MEMORANDUM

To: The Design Advisory Board
From: Mary O'Neil, AICP, Senior Planner *none*
RE: ZP 14-0499CA/MA; 237 North Winooski Avenue
Date: November 12, 2013

Overview: The former Dairy Queen, constructed in 1964, is proposed to be demolished and replaced with a mixed use building containing 28 residential units and approximately 1,500 sf of commercial space. Parking is proposed to be at grade behind streetfront commercial.

sheet no.
A2.1

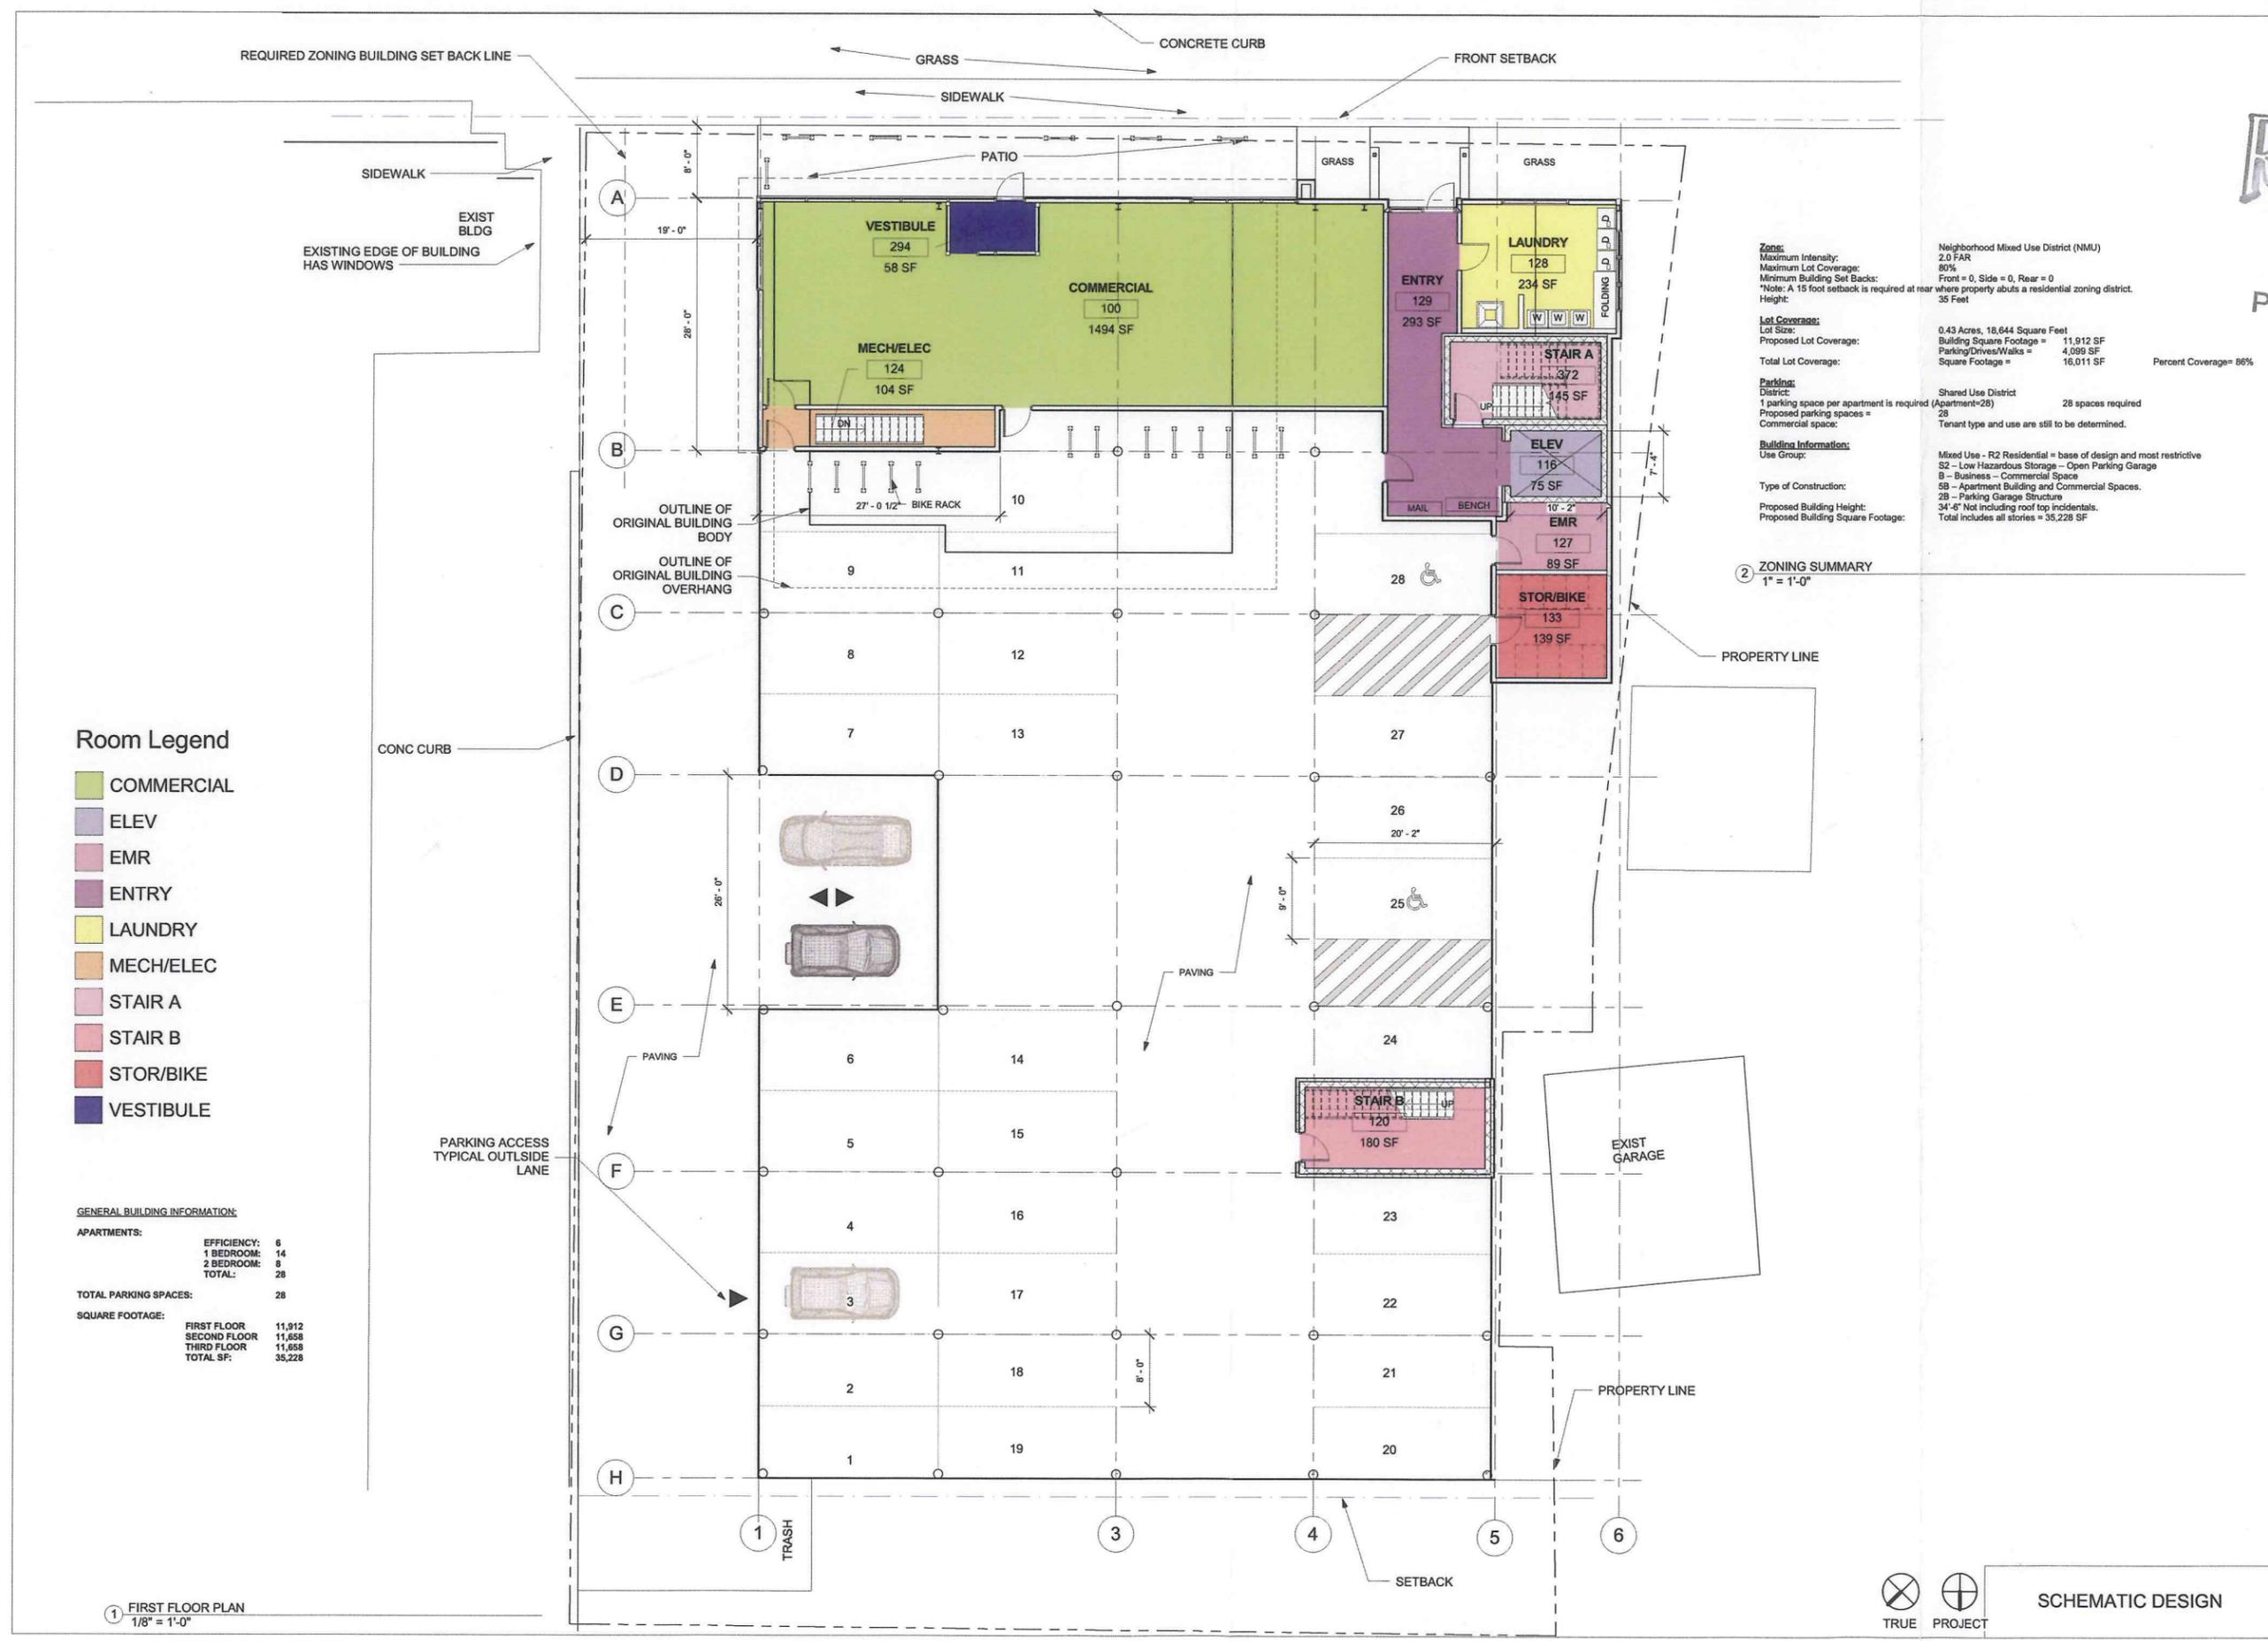
The parking access is provided via a double wide two-way lane; entering mid-structure at grade. From plan A201, it appears that easterly exterior parking spaces will be accessed by pulling-through from the entrance lane, rather than “stacked” from the interior. This “pull-through” access for exterior parking spaces may cause some confusion for the central access point, as exiting drivers will not anticipate vehicles moving in front of them. The arrangement appears to present additional vulnerability to the support columns for the structure as cars will be driving around/through them from both sides

On examination, a car accessing the garage “entrance” will not likely be able to pull into spot 14 (or maybe even 13 or 15) without a multi-point turn, as the radius would be too tight.

Only 15% of parking may be considered for “compact” parking. 15% of 28 spaces = 4 spaces. Spaces 1, 19, 2, and 18 are 8’ in width; therefore “compact” parking. Space 24 does not appear to be a full size parking space. The applicant needs to confirm dimensions of all parking.

The applicant shall confirm that all spaces have the required 24’ in back-up space. (Compact spaces – 20’.)

| The existing basement (from Q-Tees) is proposed -as a mechanical/electrical area. (Plan A2.1.) However, utility connections are not illustrated on the site plan or building elevations. This needs to be completed.

The west elevation contains windows (and a door – see color modeling image) within 5' of a property line at the west/rear of the structure. The bike storage room and elevator area do not contain windows. (See plan A2.1.) To meet this standard, there may not be any windows in the residential area over parking spaces 22 and 23 – presumably where paired single hung windows are now illustrated. Confirmation of this standard, and required building code, shall be discussed with the building inspector.

sheet no.
A4.1

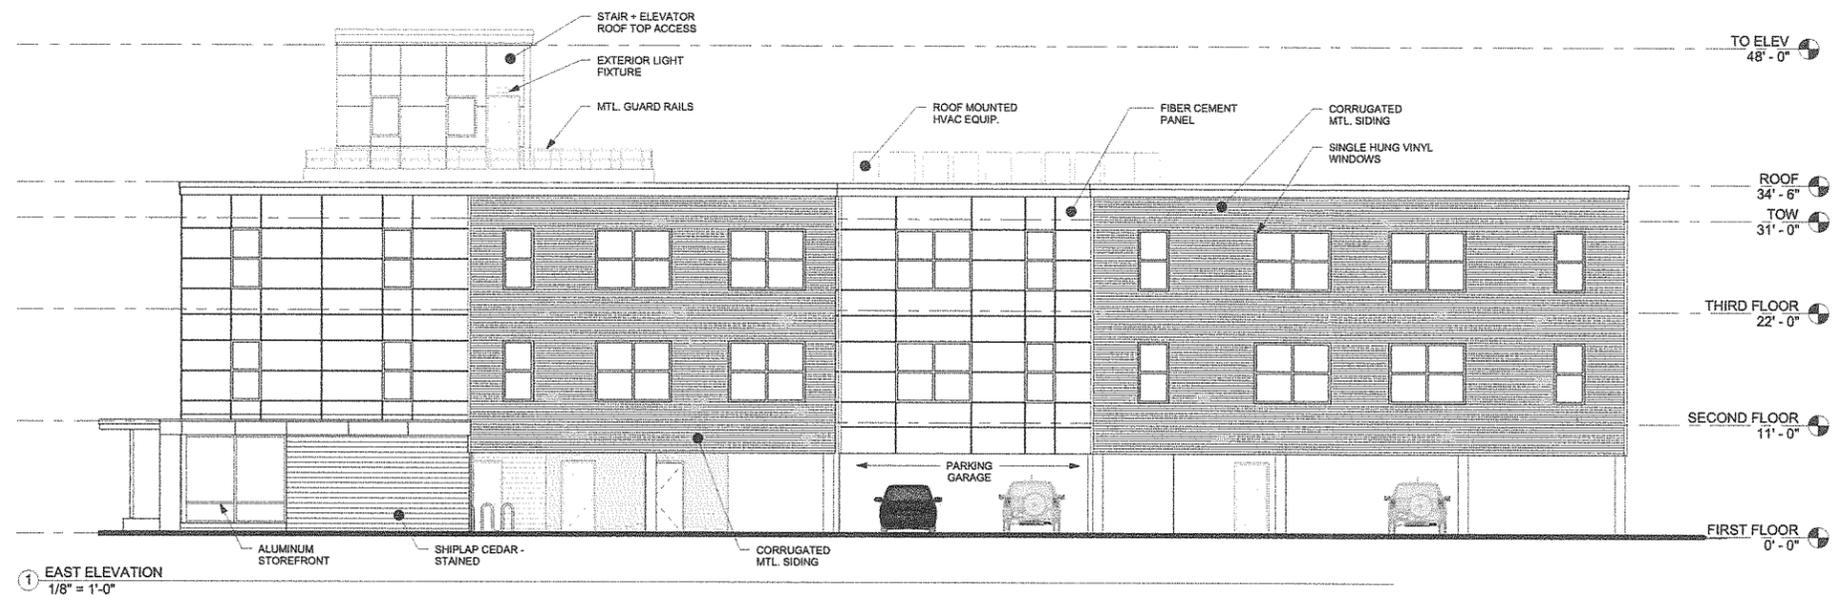
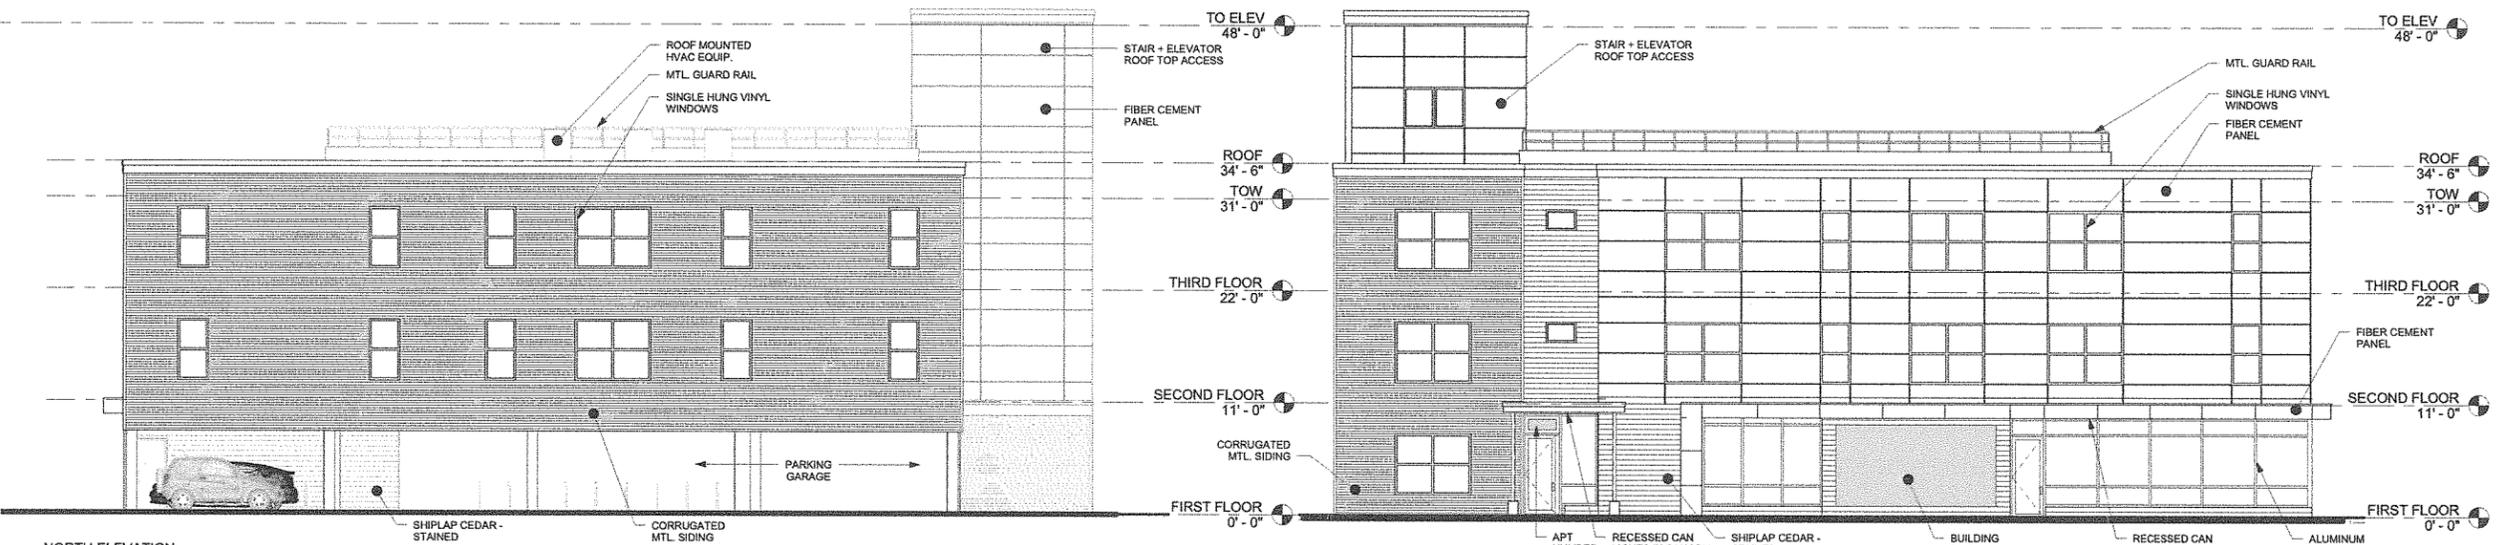
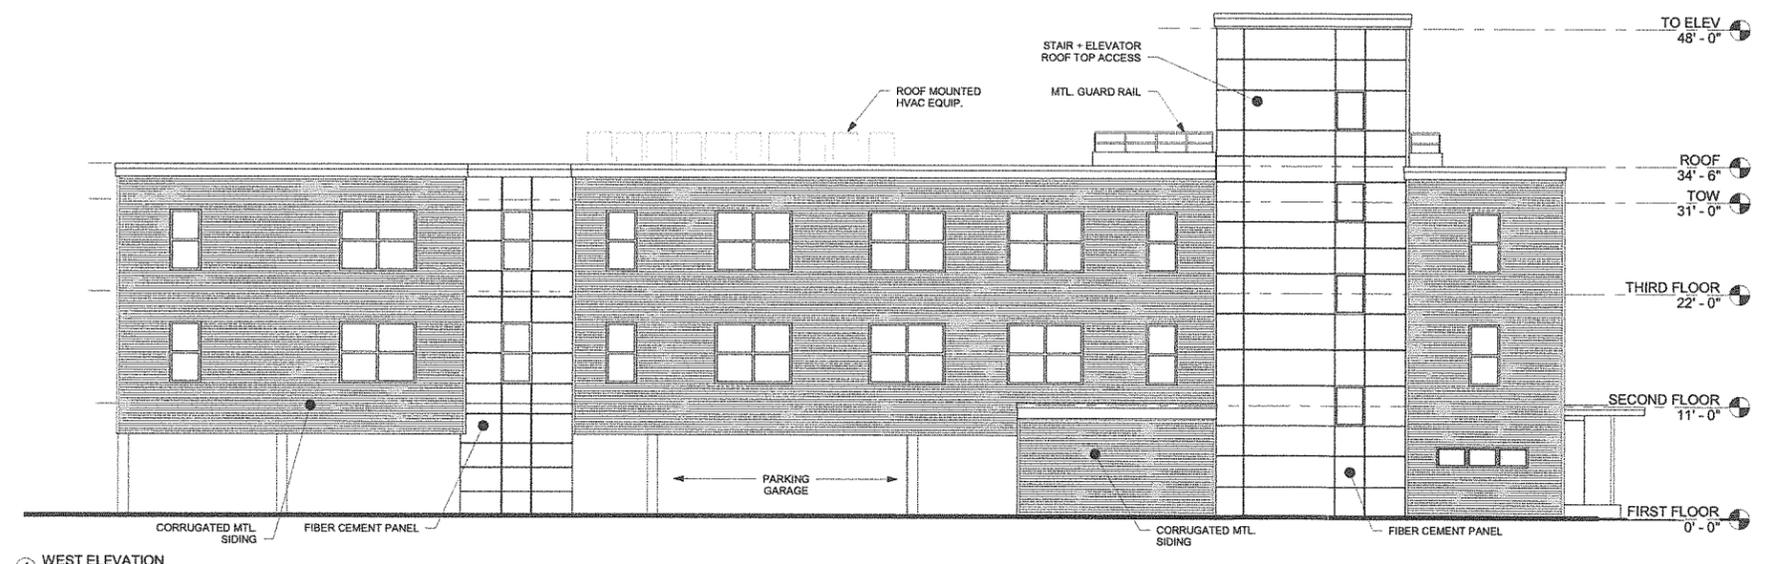
Other than the stair tower/elevator assembly, the windows are arranged warehouse-like horizontally across the blocky frame. There is little variation or arrangement to inspire interest or enliven the building elevations.

The decorative band-like canopy along the commercial frontage will be required to meet the 8' height standard.

Basic articulations are present: A projected canopy for the residential entrance, an articulated false canopy (illustrated in a bold color) for the proposed commercial space. The elevator/stair tower's function is obvious in its height, but the remaining building is massed like a lego structure; the only additional expression made in color.
